UNITED STATES PATENT AND TRADEMARK OFFICE

| APPLICATION NO. | FILING DATE | FIRST NAMED INVENTOR | ATTORNEY DOCKET NO. | CONFIRMATION NO. |
|-----------------|-------------|----------------------|---------------------|------------------|
| 09/810,228 | 03/19/2001 | Noriyoshi Shida | 040894-5642 | 6917 |

Office Action Summary

FIG. 1

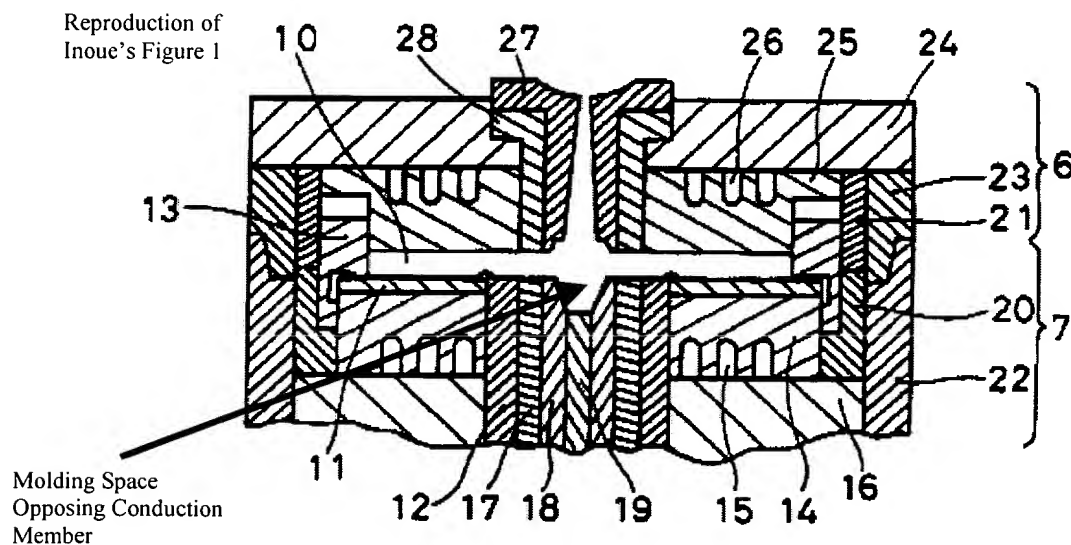
Inoue further teaches the mold to comprise a molding space disposed at a portion at the other of pair of mold bodies opposing to the conduction member (see below). As broadly construed, such the space has almost the same volume as the conduction member as recited in claim 6 (note the rejection of claim 6 under 35 USC 112, second paragraph above).
